Sep. 2nd , 2025

Connectors Modification
for BM-20M Motor of CM20 Controller
Change Notification

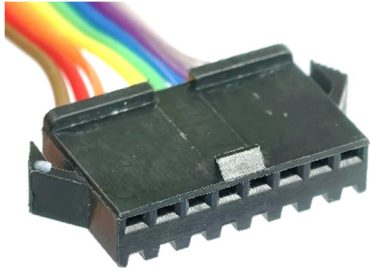
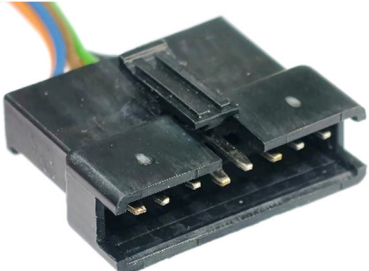
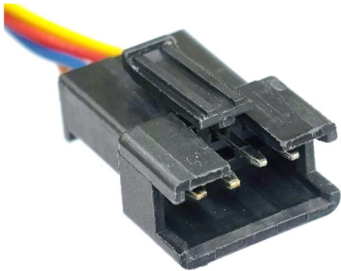
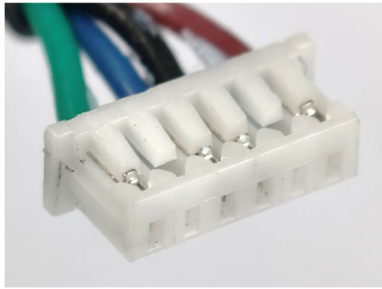
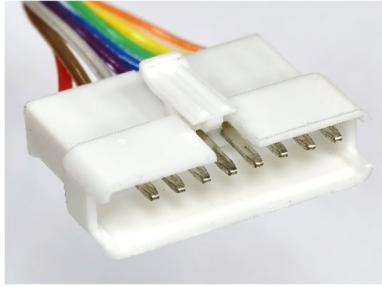
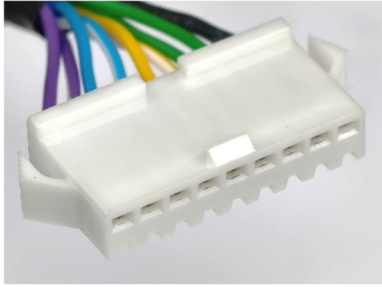
Changed connectors of encoder and motor cable,
as shown on next page.

Model Series	BM-20M motor of CM20 controller
Before	CM20-20-E** 53047-0610 51021-0600 SM-8A SM-8Y SM-4Y SM-4A CM20-20-M** Connecting to a short adapter cable first, and then to an extension cable. BM-20M
After	CM20-20-E** 53047-0610 51021-0600 SMP-09V-NC SMR-09V-NC CM20-20-M** Connecting to an extension cable directly. BM-20M
